Bi-weekly Seismic Call Meeting Agenda

Date: 2016-7-13

26. RAI 208-8245, Question 03.08.03-6

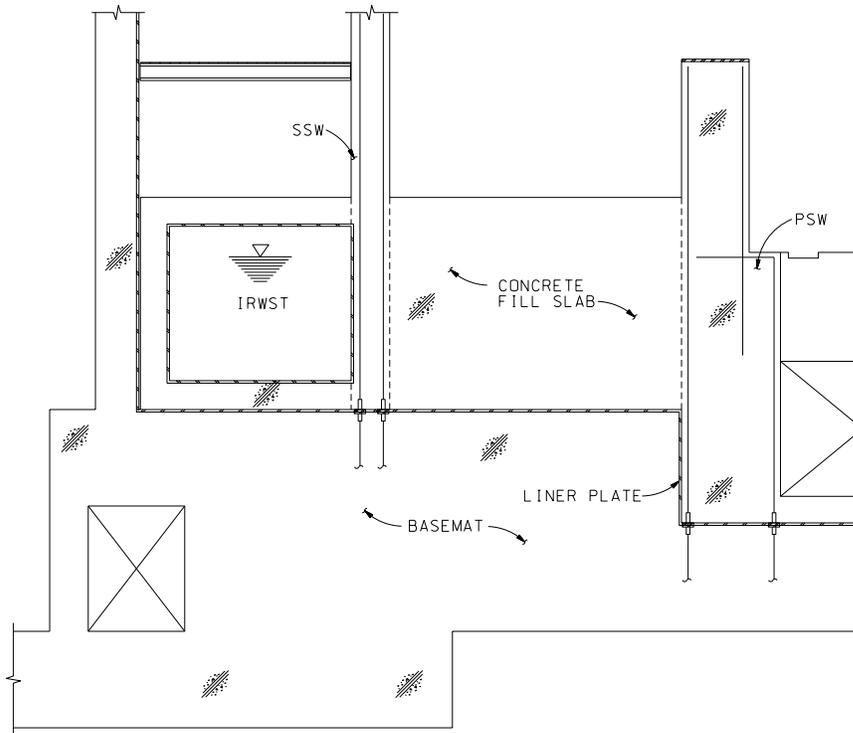
1. The applicant response to part 1 is acceptable - Confirmatory Item
2. The applicant response to part 2 states, "The impulsive mode primarily acts to stress the wall, whereas the convective mode acts primarily to uplift the wall." The applicant is requested to clarify this statement. The convective mode also applies stresses on the IRWST and should be combined with the impulsive mode. The applicant is also requested to explain what is meant by the statement: "Therefore, considering the impulsive mode over the water level is more conservative than considering both impulsive and convective modes," and why considering only the impulsive mode is more conservative.
3. The applicant response to part 3 is acceptable - resolved/closed.
4. The applicant response to part 4 is acceptable - resolved/closed.

Consider the height of water is H (i.e. $H = H_1 + H_2$) which consists of convective height (H_1) and impulsive height (H_2). As mentioned above, the pressures due to the height H_1 and H_2 acts in different phase with each other and the convective effect is smaller than the impulsive effect. The terms "considering the impulsive mode over the water level" means that the pressure of the height H ($H_1 + H_2$) is considered as the impulsive mode and not the pressure in the height H_2 is only being considered as the impulsive mode. Therefore, the pressure considering the impulsive mode over the water level (H) is more conservative than considering both impulsive (H_2) and convective (H_1) modes.
